John F. Kennedy Museum

Town of Barnstable ADA Transition Plan

July 2021

Institute for Human Centered Design

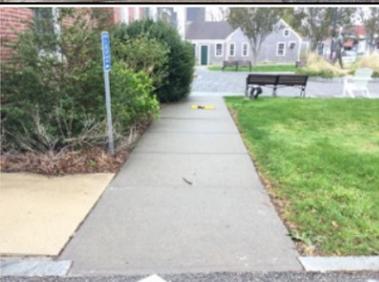
- Recommend providing benches with a back and armrest (Kennedy Family Tree Room).

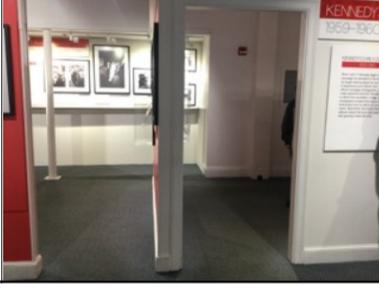
ID	Location	Floor	Room	Element	Type	Photo	Issues	Current Measure	Recommendations	Quantity	Price	Cost Estimation
Approach and Entrance												
Exterior Access Route												
1	Towards Accessible Entrance	Ext.		Exterior Access Route	Exterior		Surface openings > 1/2"	1"	Repair surface.	1	-	\$0
2	To Sidewalk Along Library From Accessible Parking at Town Hall Lot	Ext.		Exterior Access Route	Exterior		Cross slope > 1:50 (2.00%)	3.4%	Reduce cross slope to be no steeper than 1:50 (2.00%).	1	-	\$0
3	Path Near JFK Main Entrance From Sidewalk Along Library	Ext.		Exterior Access Route	Walkway		Cross slope > 1:50 (2.00%)	3.9%	Reduce cross slope to be no steeper than 1:50 (2.00%).	1	-	\$0
4	Sidewalk by USPS Along Exit Driveway Towards Town Hall Lot Parking	Ext.		Exterior Access Route	Sidewalk		Cross slope > 1:50 (2.00%)	4.2%	Reduce cross slope to be no steeper than 1:50 (2.00%).	1	-	\$0
5	Path From Accessible Entrance to Main Entrance	Ext.		Exterior Access Route	Walkway		Route not maintained in operable working condition Obstructed by protruding objects	-	Trim bushes to maintain the required width at the accessible route. Ensure the accessible route is maintained in operable working condition.	1	Labor	\$0
